INTERCHANGE PARK SUBDIVISION, UNIT ~ 1

INTERCHANGE PARK

PRELIMINARY OVERALL AREA DEVELOPMENT PLAN

Re: Interchange Park ☐ Preliminary Plan
File #: 84-19-61-00 ☒ P.O.A.D.P. Revision
dated Jan. 31, 1985

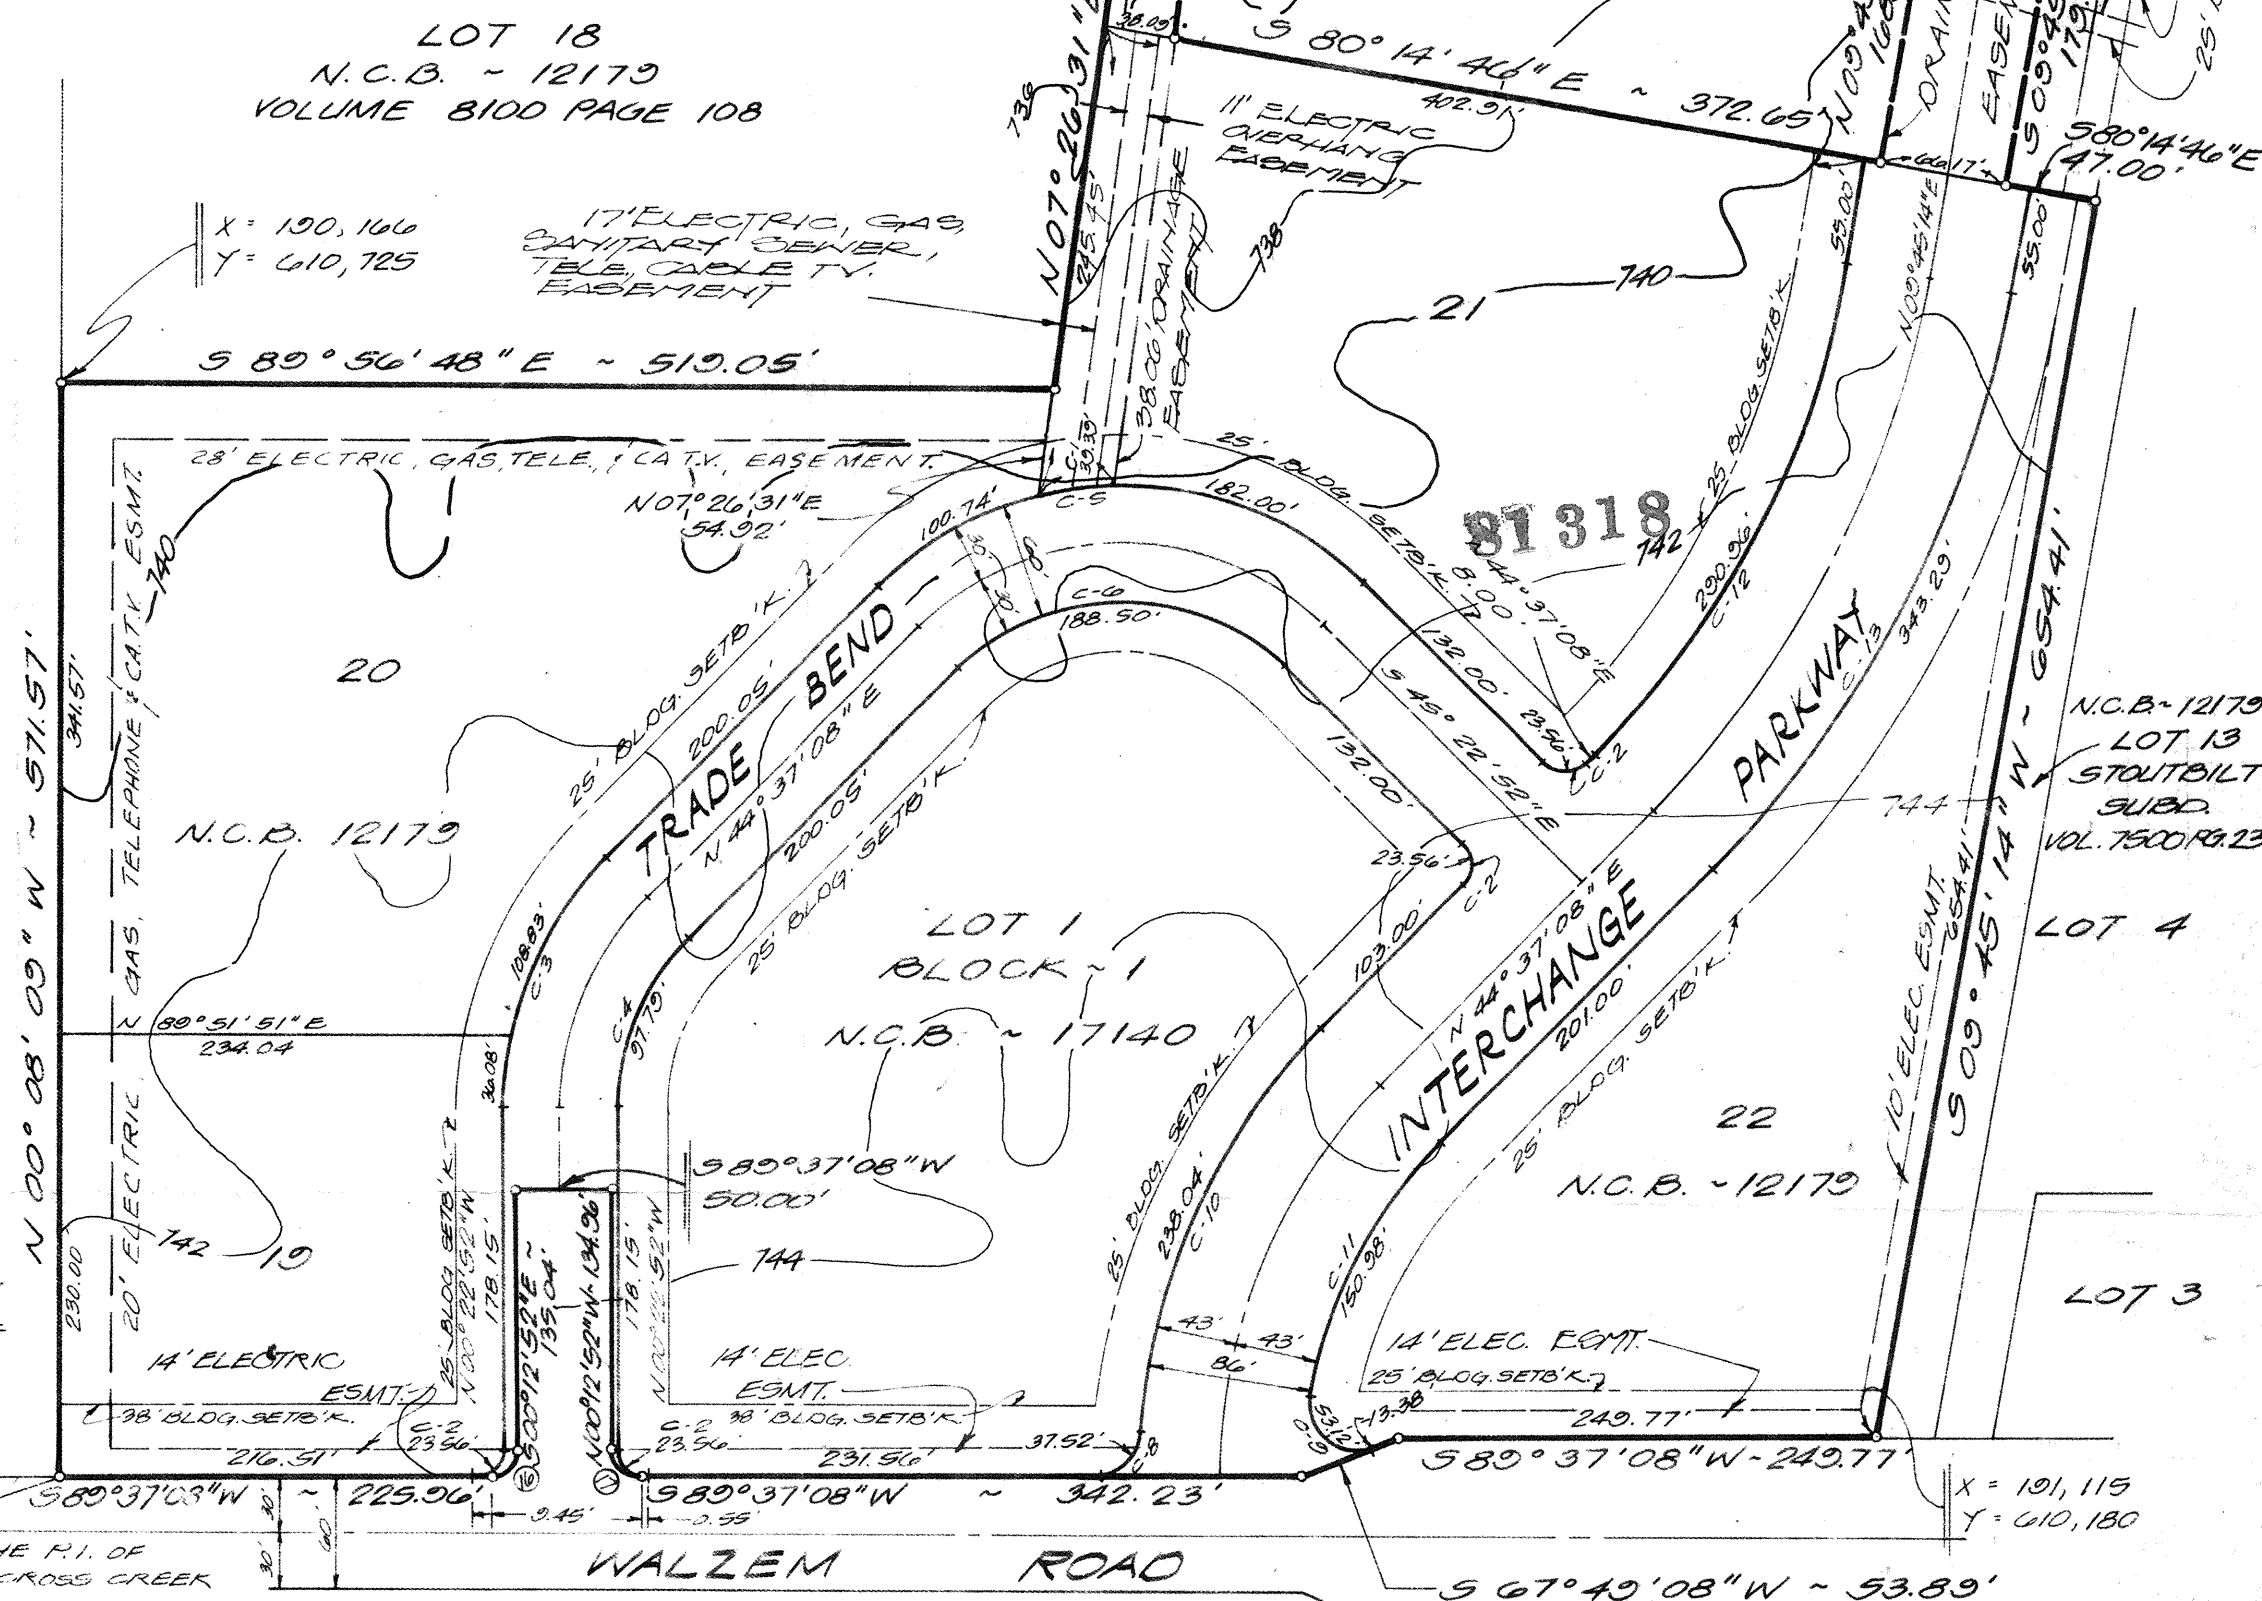
- Denote previous struct alignment

Revised P.O.A.D.P.
reflects new student
alignment

(xx) Comments: Staff has no objection to the new street alignments as reflected on the revised POADP.
